HISTORIC LANDMARKS COMMISSION

February 8, 2018

Subject: **REQUEST FOR CERTIFICATE OF APPROPRIATENESS HLC2017-030**, submitted by George Haley, property owner, for exterior material alterations and additions to property located at 139 and 147 East Washington Street. The property is further identified as Zoning Map 34G18, Block A, Parcel 282*283, Suffolk Voting Borough, zoned CBD, Central Business District, and HC, Historic Conservation Overlay District.

STAFF REPORT

Existing east elevation:

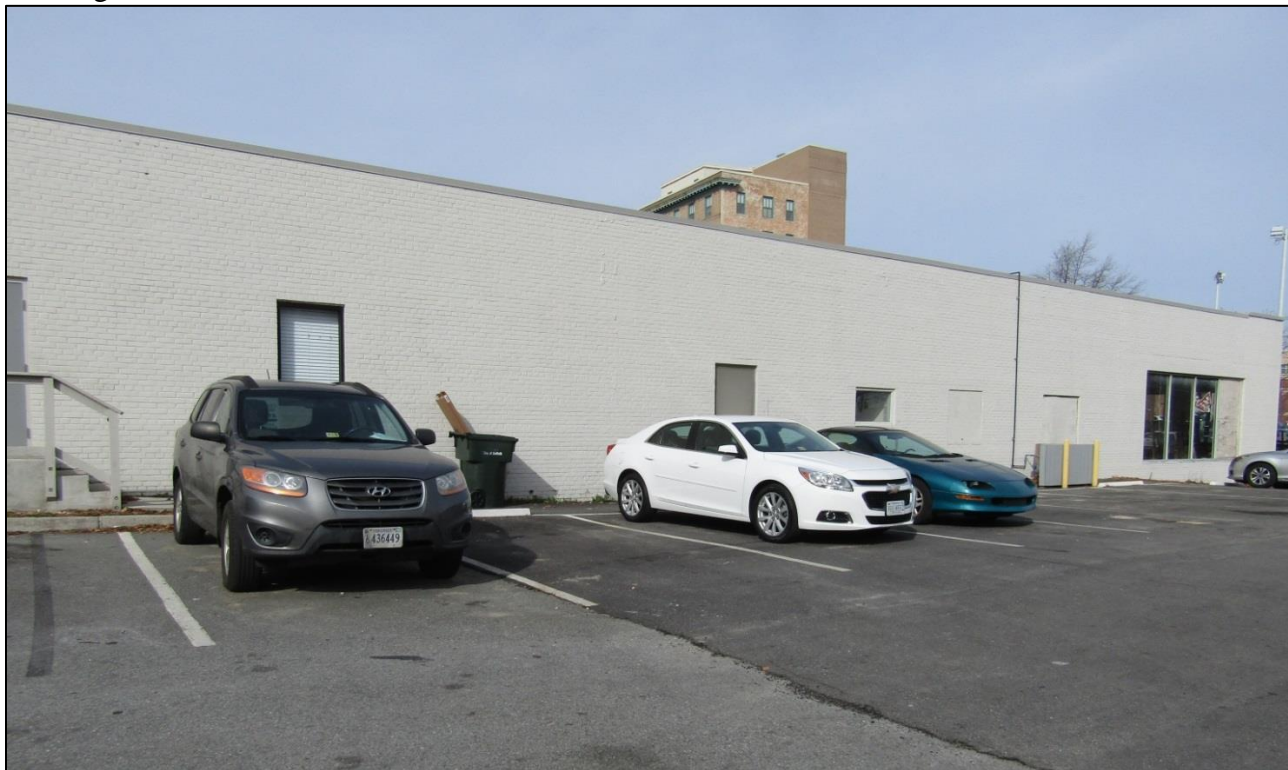
Location of proposed ramp and handrail, new windows, and replacement door on east elevation:

Existing windows, ramp, and handrail on east elevation installed without a COA. (The door shown is not in compliance with previous COA):

1. Remove four (4) existing fixed aluminum windows on the east elevation facing the parking lot and replace them with four (4) fixed aluminum windows and raised panels that match the front elevation. The panels shall be painted Geddy Gray (CW-720 or equivalent) in order to match the panels on the north elevation.
2. Install four (4) fixed aluminum sixteen (16) light windows with exterior muntins in accordance with the submitted elevations.
3. Install one (1) new concrete ramp and traditional wooden handrail, consistent with the submitted elevations. The handrail shall be painted Bruton White (CW-710 or equivalent) to match the brick building walls. The ramp must comply with the Uniform Statewide Building Code.
4. Install one (1) additional black metal door consisting of raised panels to match the other proposed exterior doors.

1. Retain three (3) existing aluminum fixed windows with black frames on the east elevation; however, exterior muntins must be installed to create sixteen (16) divided lights in accordance with the submitted elevations or they shall be replaced accordingly.
2. Retain the existing concrete ramp on the east elevation. Remove the wooden handrail and replace it with a more traditional wooden handrail, consistent with the submitted elevations. The handrail shall be painted Bruton White (CW-710 or equivalent) to match the brick building walls. Compliance with the Uniform Statewide Building Code must be verified.
3. Replace one (1) existing solid grey metal door with a black metal door consisting of raised panels (to come into compliance with the door style approved from application HLC2015-016).

Proposed Elevations for HLC2017-030

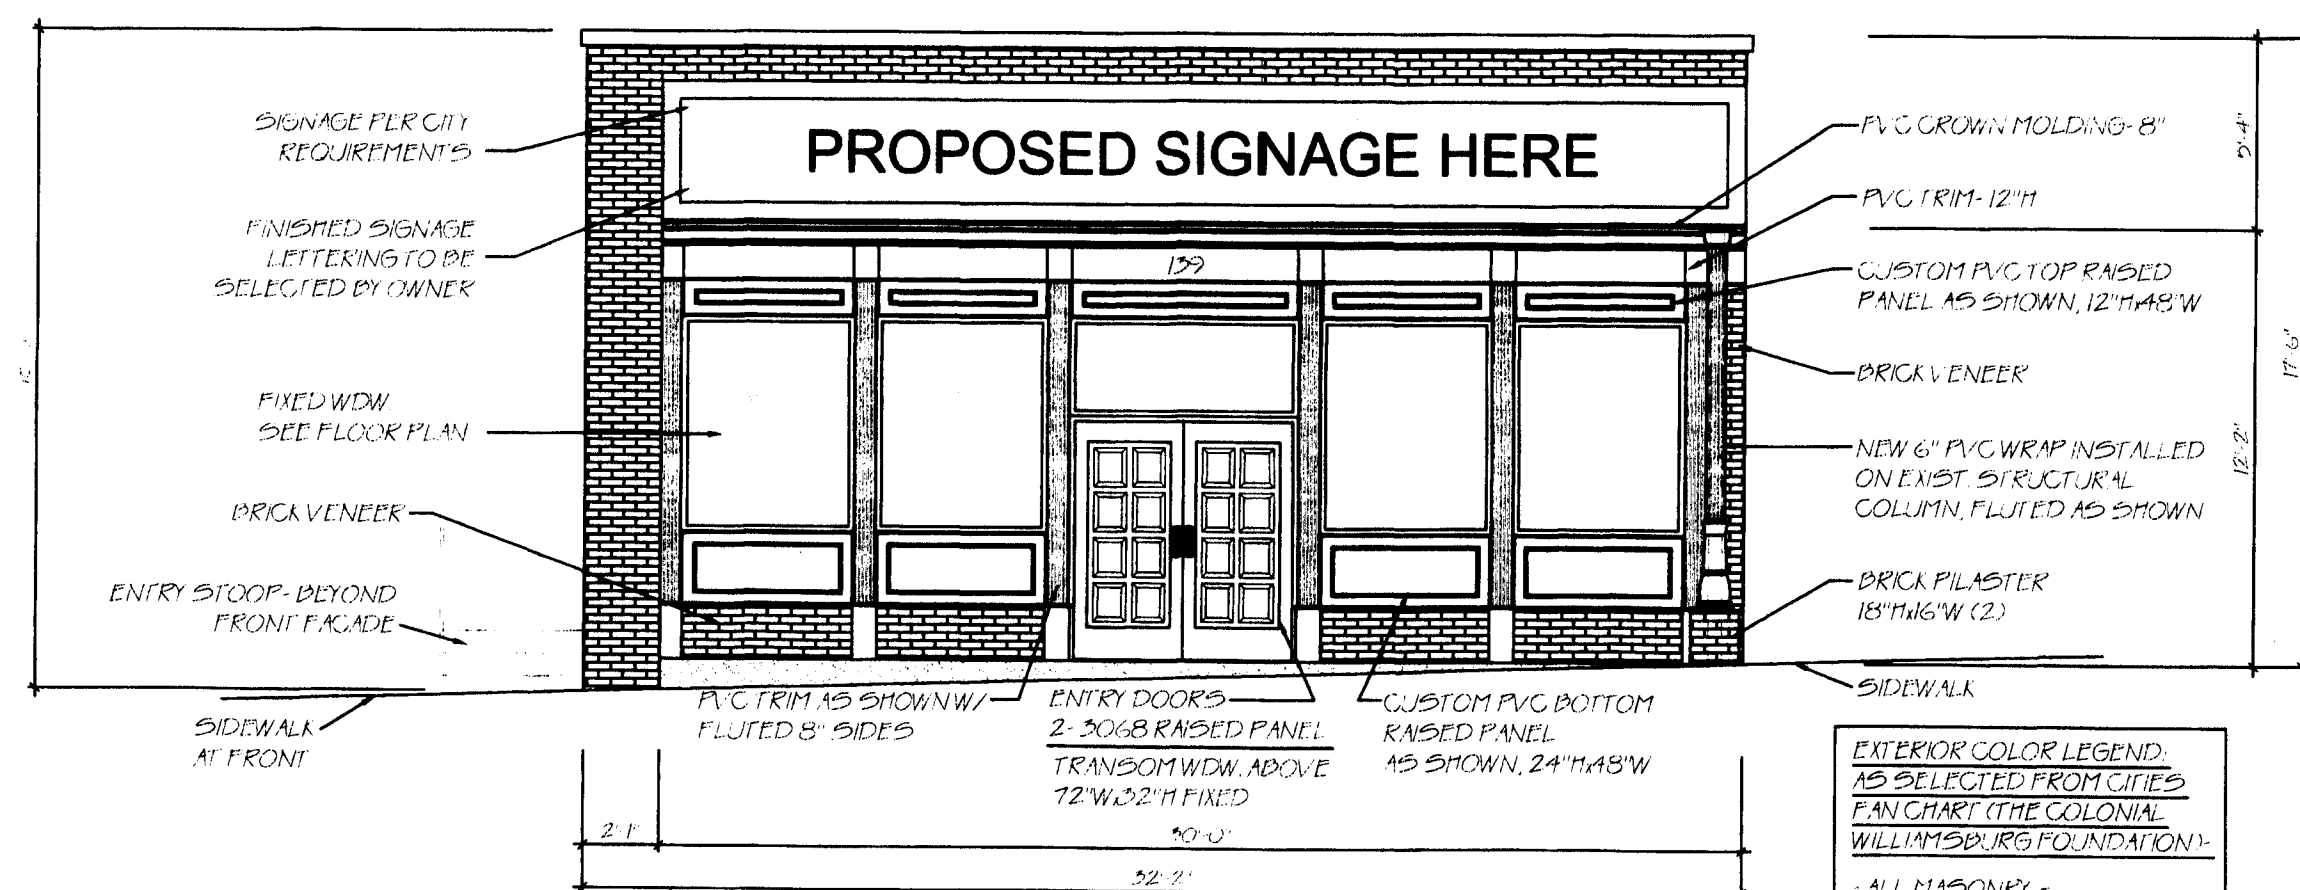
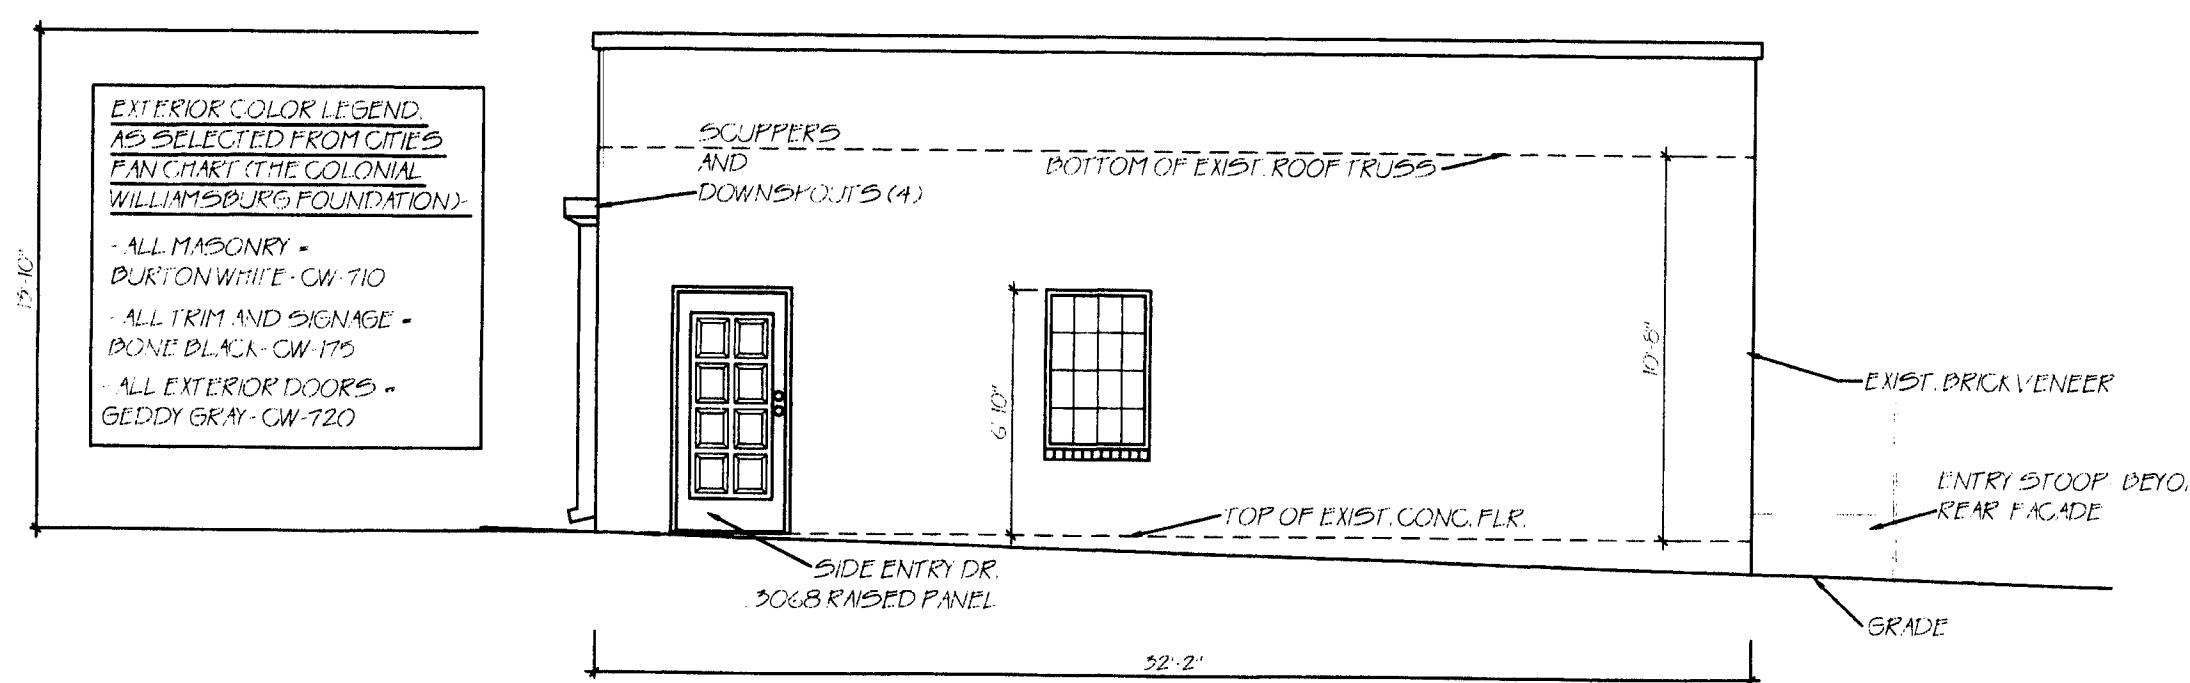
As previously stated, the subject property has been substantially altered such that many of the original mid-century modern features have been removed and the building is no longer contributing to the Historic District. As recommended in the Historic District Design Guidelines, exterior alterations to non-contributing buildings should be designed to complement and not detract from historic properties in the district. Therefore, new alterations should take their design cues from surrounding structures and utilize consistent materials, where appropriate, without artificially mimicking historic elements. The newly proposed windows and doors should relate to other window and door styles found in the district.

Metal raised panel doors are appropriate for the north (front) elevation of this building as it no longer contains mid-century modern architecture and the storefront windows now consist of a more traditional design. The proposed doors are the same as the previously approved doors from HC2015-016, which were not installed. Currently, the boarded up front doors are not in compliance with the previously approved elevations and they detract from the building's appearance. In the approved elevations from HC2015-016, an existing column on the right side of the storefront was required to be refaced with a new brick base and decorative column. This work was not completed; hence, it is recommended that this work be included as part of the new COA. Upon a site visit to the property, it was brought to staff's attention that a small fence was installed on the front elevation between the column and building wall without approval. This fence detracts from the storefront appearance and is uncharacteristic of the Historic District; therefore, it should be removed.

Solid metal security doors are currently in place on the east and south elevations, which are not in compliance with the approved elevations from HC2015-016. The exterior door on the west elevation is currently boarded up; therefore, it also does not comply with the previous elevations. The three (3) aforementioned doors should be replaced with decorative raised panel doors in order to comply with the previously approved elevations, as well as to create consistency throughout the facades, and improve the overall aesthetic of the building.

In regard to the proposed windows on the east elevation, since matching storefront windows and raised panels were previously approved on the front elevation, the proposed fixed windows consisting of black frames and raised panels would create consistency on the building. In addition, new windows would provide improved visibility between the public right of way and the commercial use. The second window style proposed consists of a fixed, divided-light, aluminum window consisting of sixteen (16) lights. This window style is similar to the original windows on the west elevation; thus, it is appropriate, provided that the windows utilize exterior

Based on the previous findings-of-fact, staff recommends **approval** of the following actions requested by Certificate of Appropriateness, HLC2017-030, with the conditions noted below:

1. Install two (2) new black metal doors with raised panels, consistent with the submitted elevations.

1. Reface the existing column on the right with a new brick base to be painted Bruton White (CW-710 or equivalent) and decorative column to be painted Geddy Gray (CW-720 or equivalent), substantially in accordance with the submitted elevations and existing paint colors.

2. Remove the wood fence located between the column and building face.
